Clover Creek Solar Project LLC d/b/a New Frontiers Solar Park
Responses to Siting Board Staff's First Request for Information
Case No. 2024-00253

Request No. 1:

U:\2353\235301184\03_data\gis_cad\Projects\WithoutPN\Clover Creek\Clover Creek.aprx Revised: 2024-12-20 By: cohoffmann

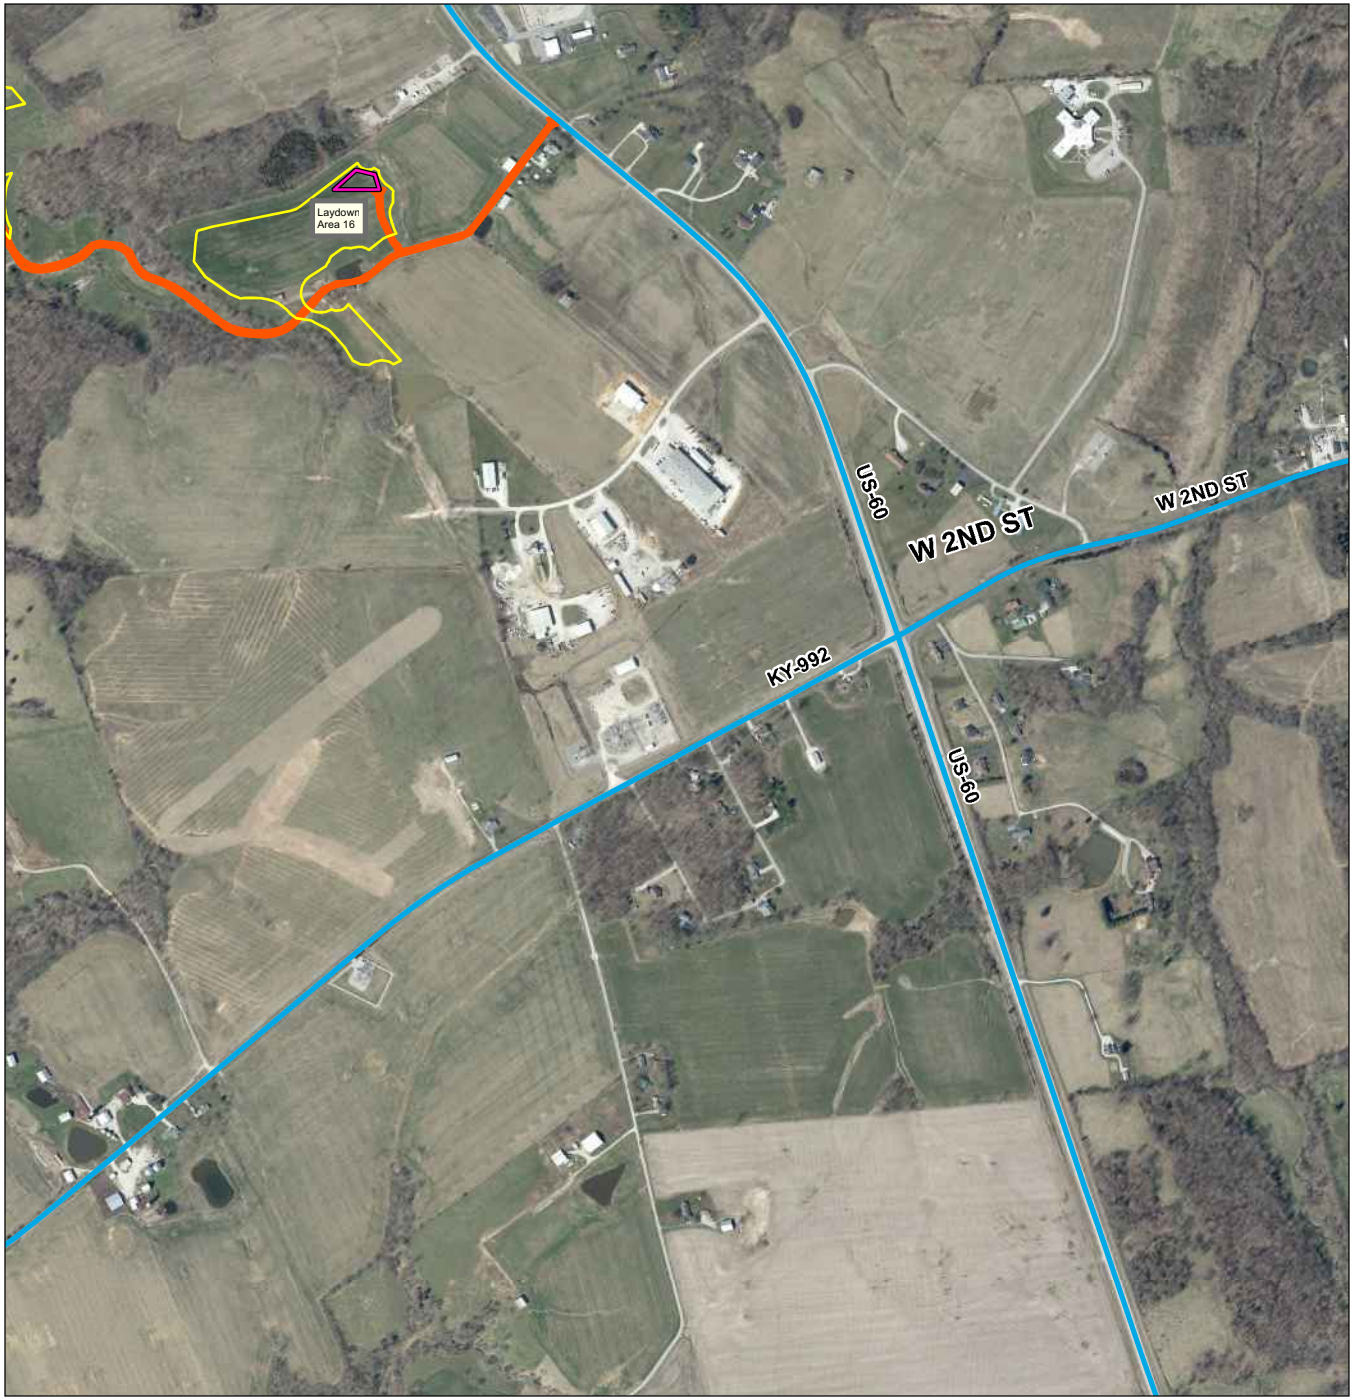
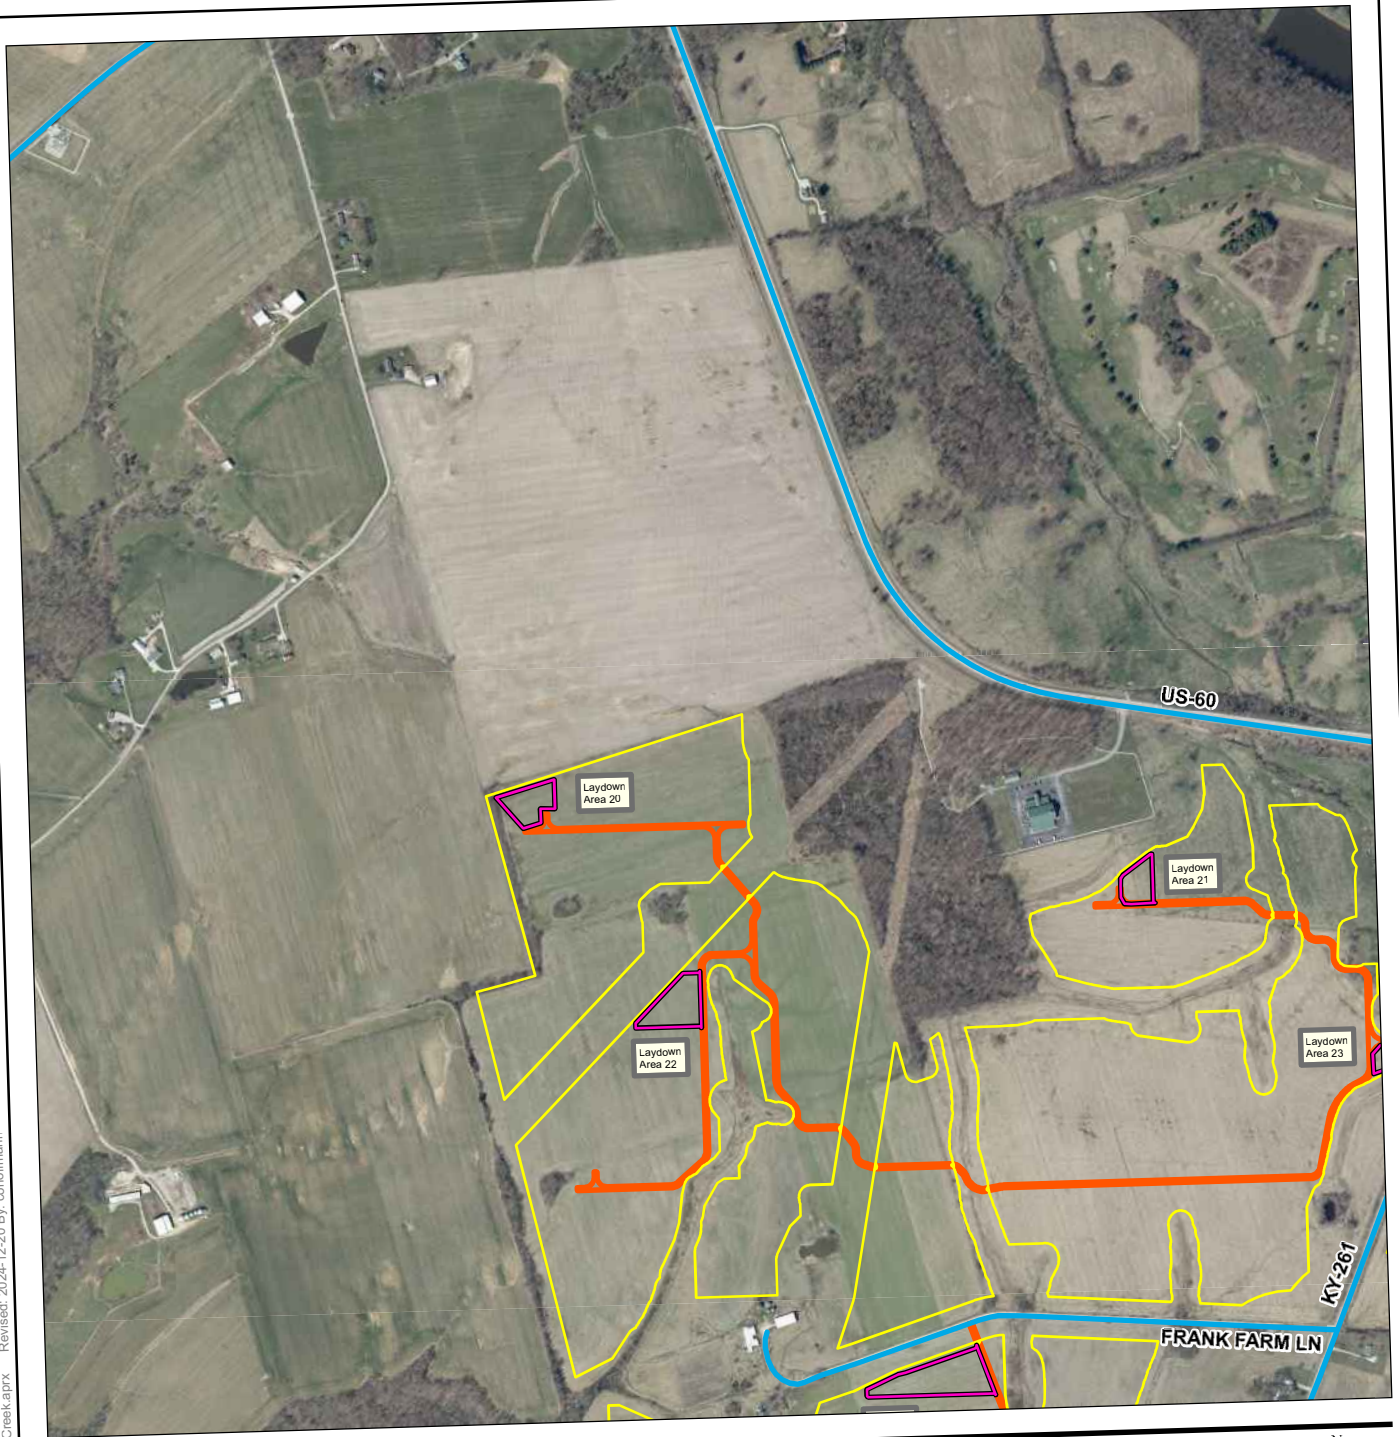
Provide a map highlighting all construction entrances to the Project site and all roads proposed to be used.

Response No. 42:

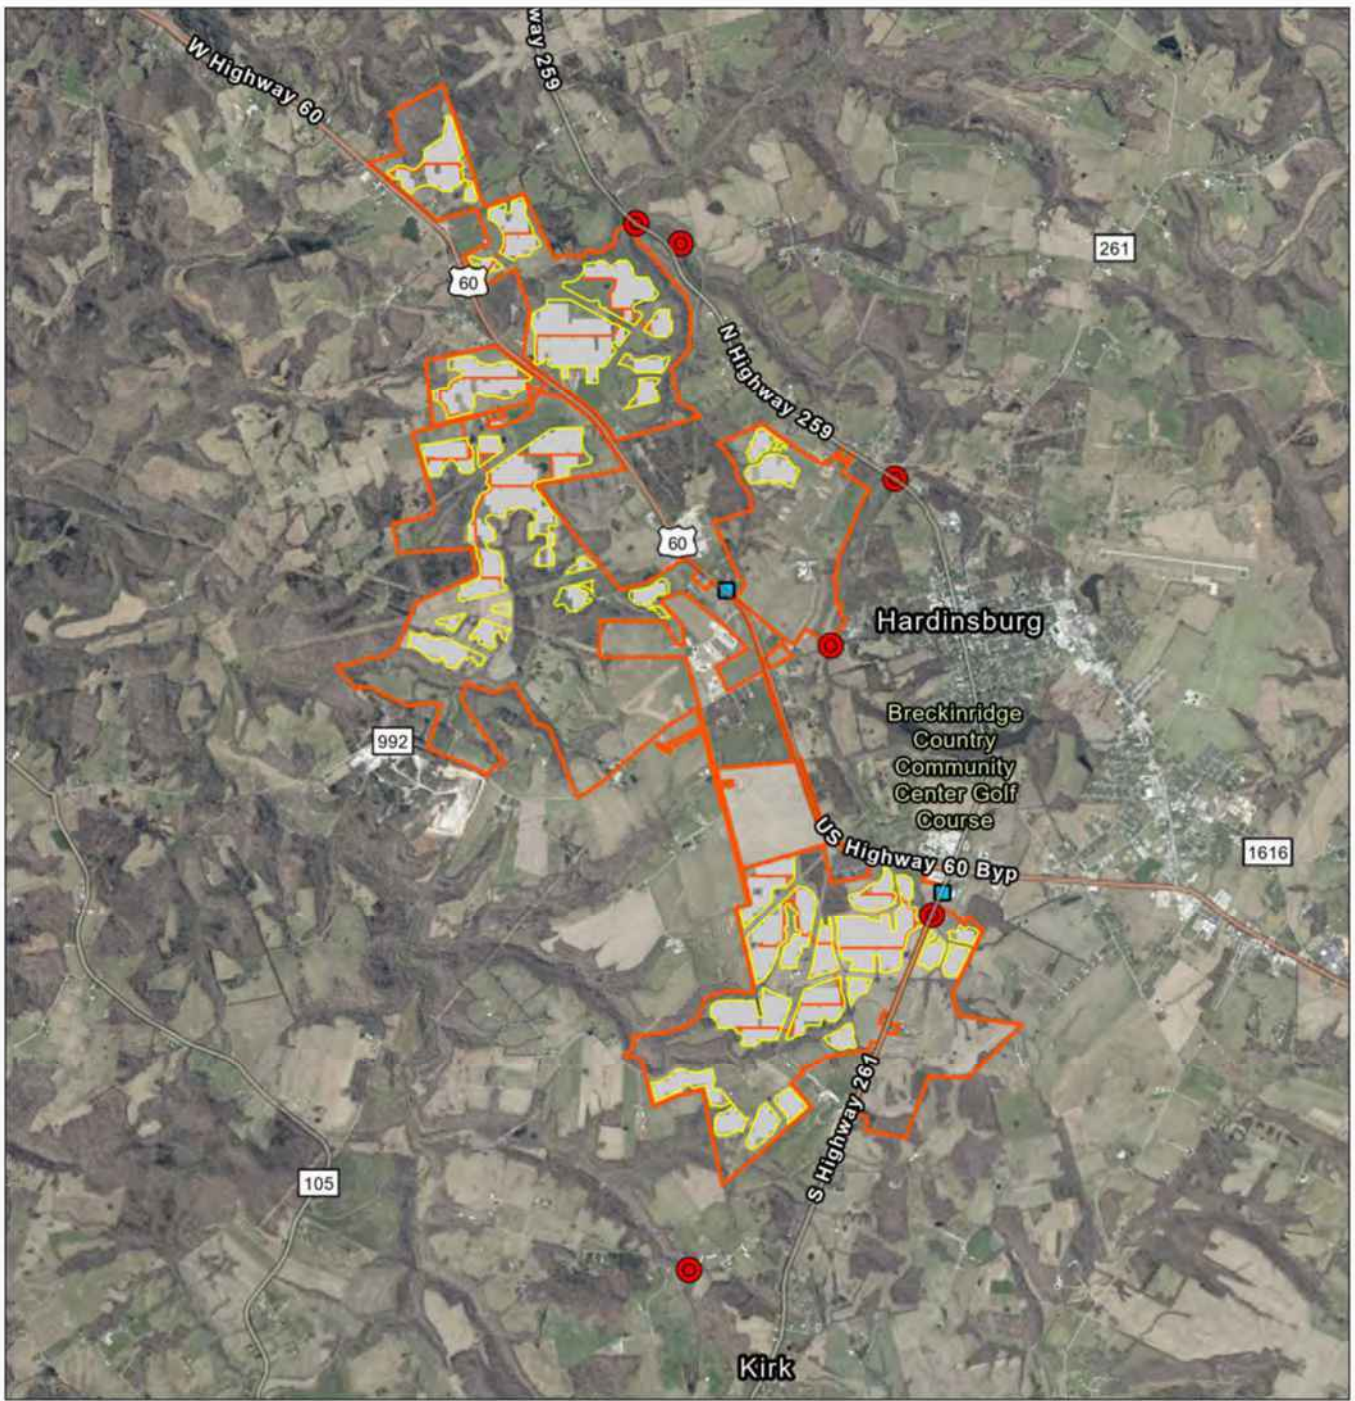
Identify all bridges along all roads proposed to be used during the delivery/construction phase of the project. Identify the width and weight capacity of each bridge and any upgrades or repairs that will need to be made prior to the commencement of construction.

**Clover Creek Solar Park
Transmission Easements
South of HWY 992**

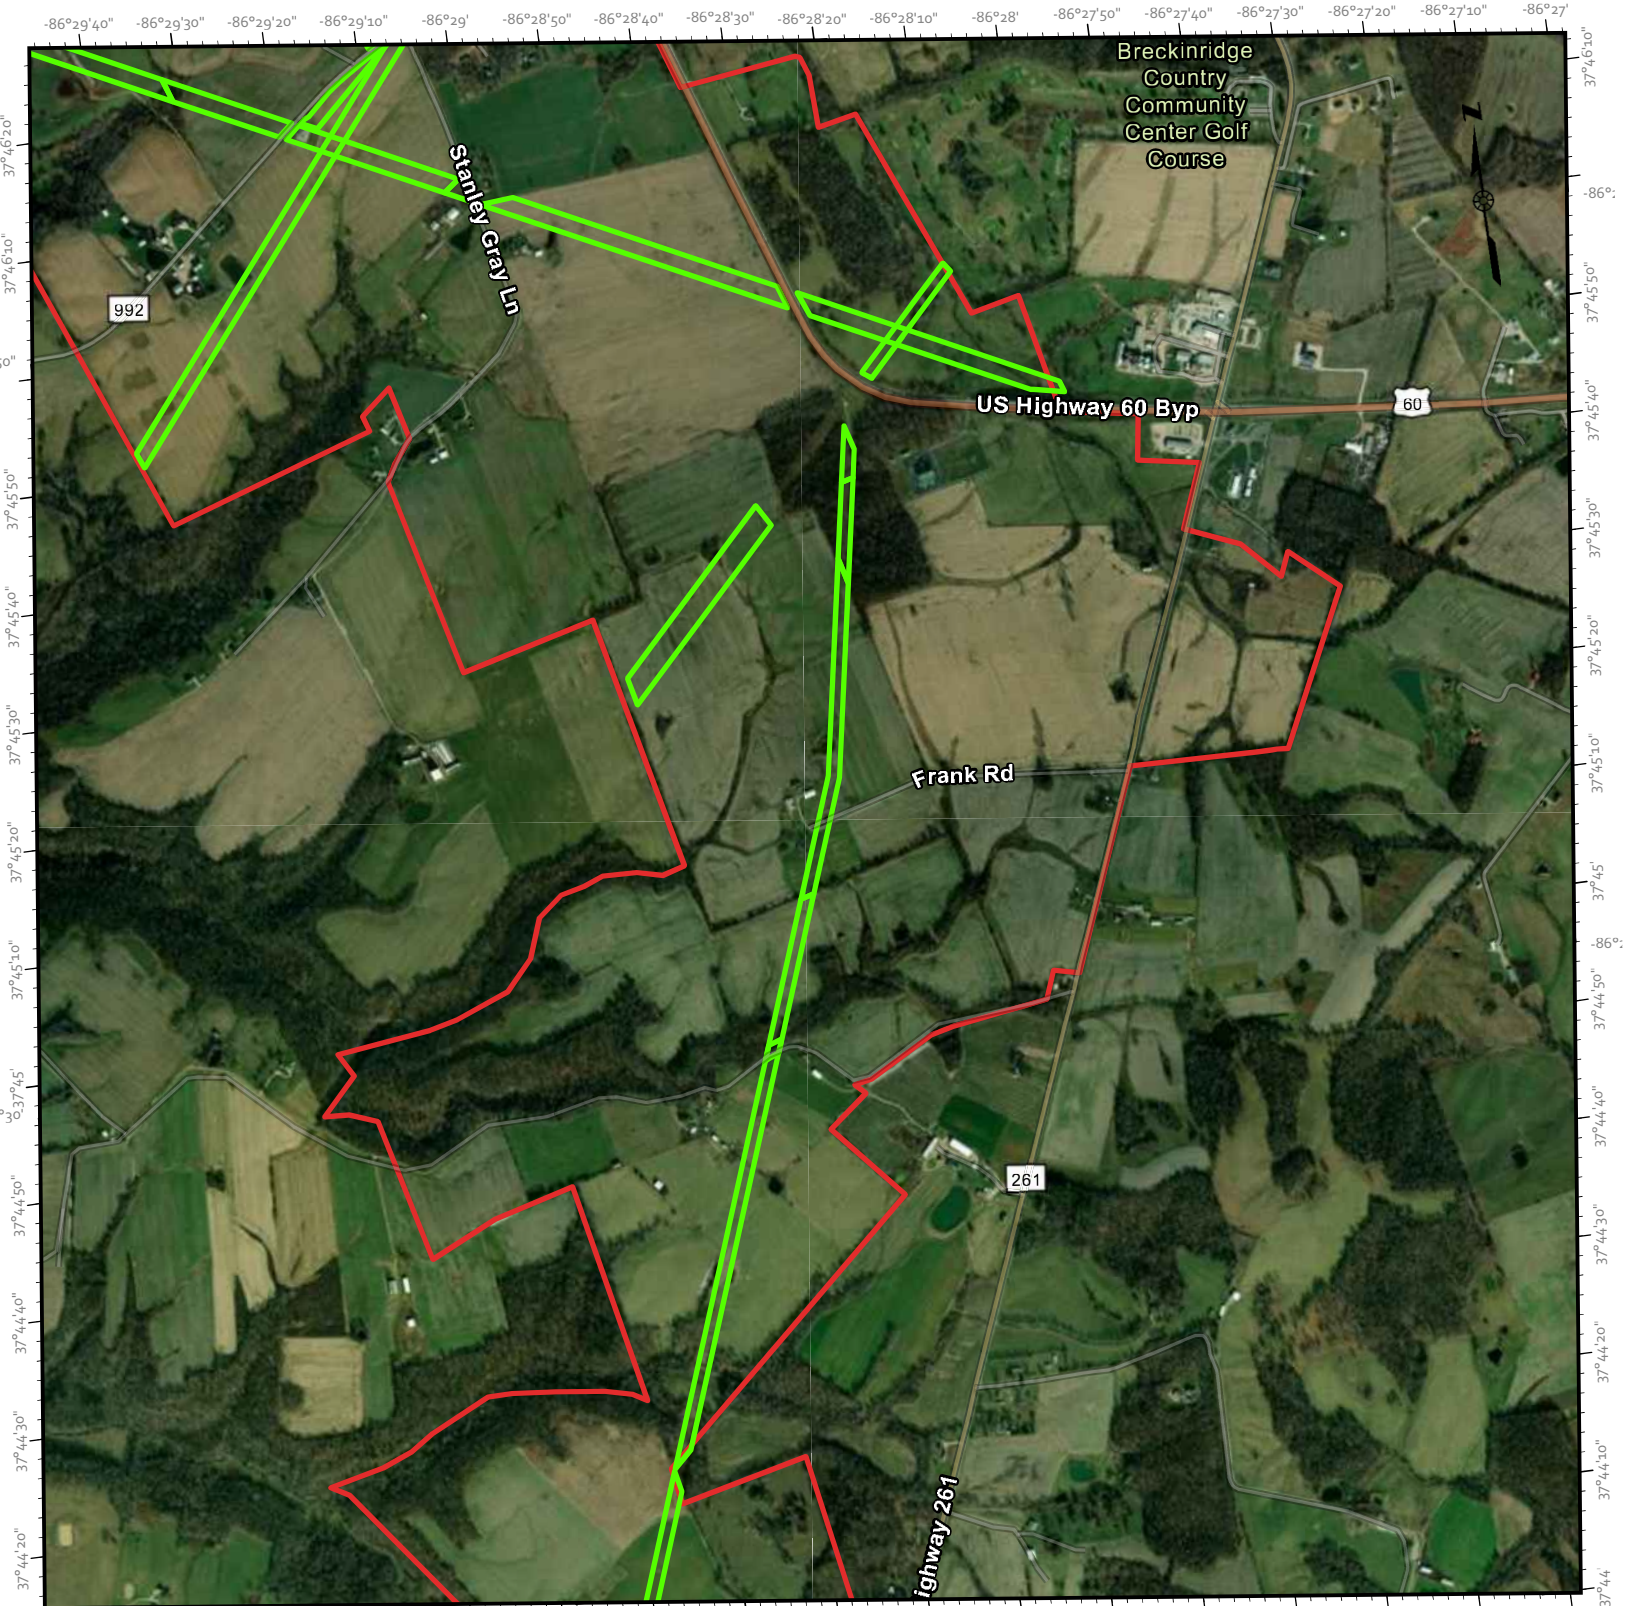
Provide the rights-of-way for all transmission lines that transect any portion of the project site.

Please see the attached map showing rights-of-way for the Project site.
